**ADDENDUM NO. 1
TO THE
CONTRACT DOCUMENTS**

**HILLCREST AND DONLON
BOOSTER PUMPING STATION IMPROVEMENTS
ANTIOCH, CALIFORNIA
P.W. 477-BP2**

September 18, 2020

- Hillcrest IO - Discrete Inputs (DDI 1602)
- Hillcrest IO - Discrete Outputs (DDO 1602)
- Hillcrest IO - Analog Inputs (AMI 0810)
- Hillcrest IO - Analog Outputs (AMO 0410)
- Hillcrest BPS PLC IO Layout

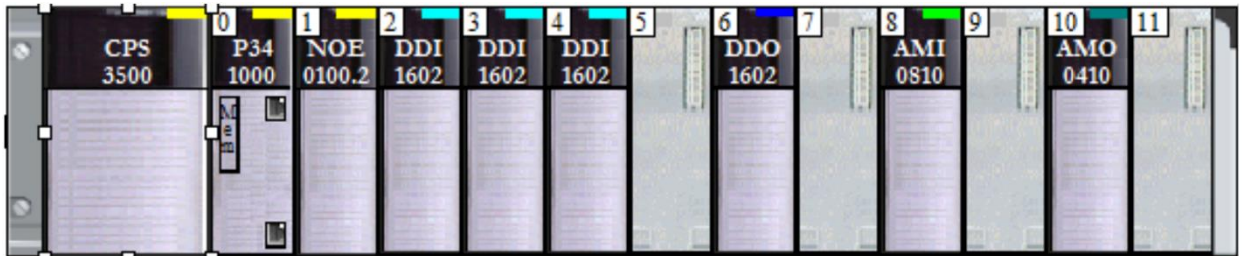
20) Specification Section 40 63 43-3.05- paragraph A, Hillcrest I/O, shall be replaced with the following attached below for convenience, and here-in in the Appendix:

DONLON EXISTING IO

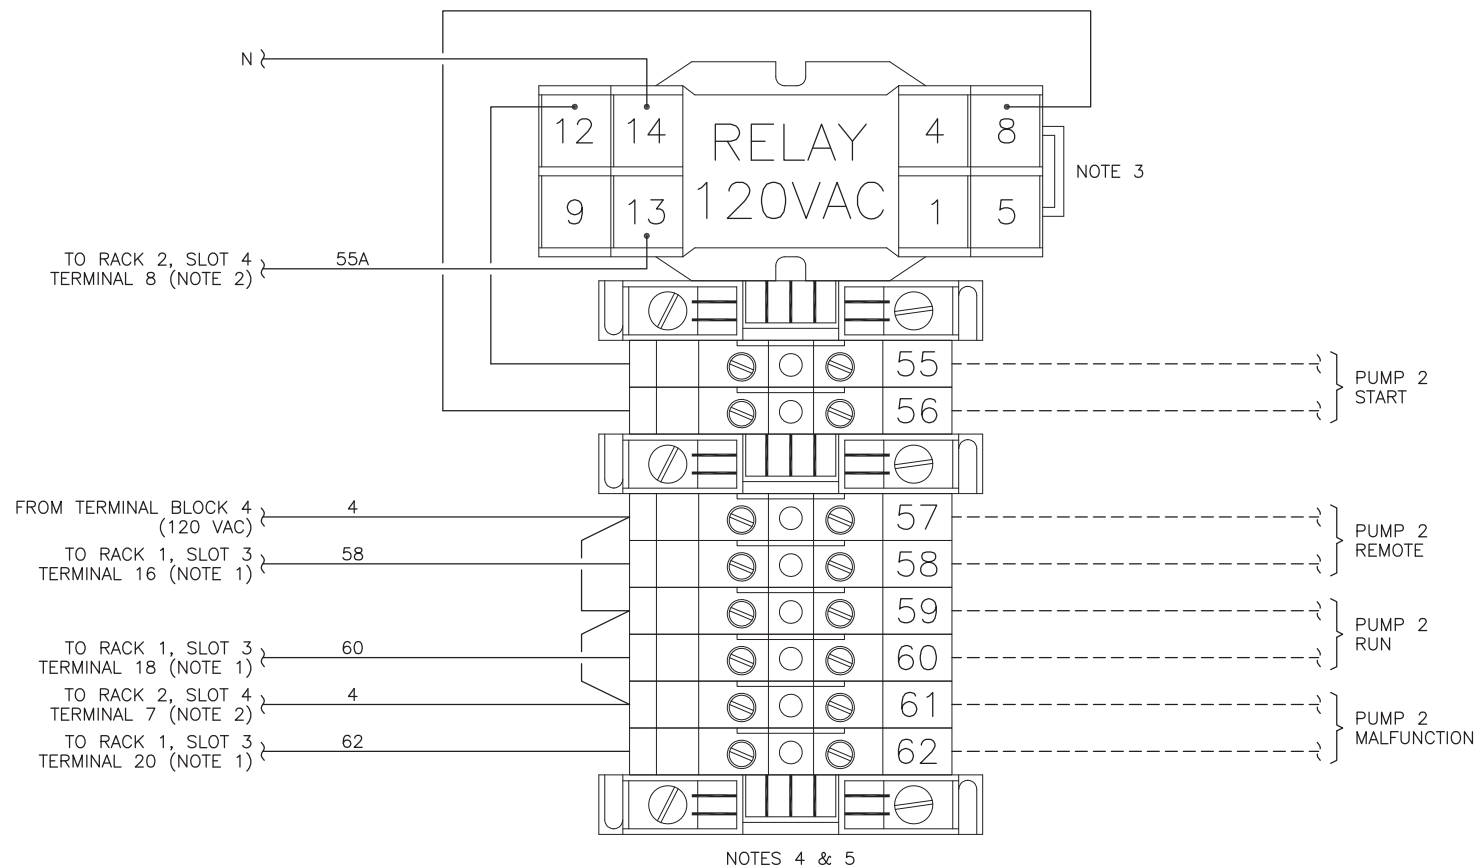
21) Specification Section 40 63 43-3.05-B Donlon I/O shall be replaced with the following:

“As previously stated, the I/O list is for reference only and represents the I/O existing at the Donlon Booster Pump Station. Contractor shall terminate field wiring as shown on Kapsch drawing no. GP12081-8001-01 attached below for convenience, and in the Appendix here-in:
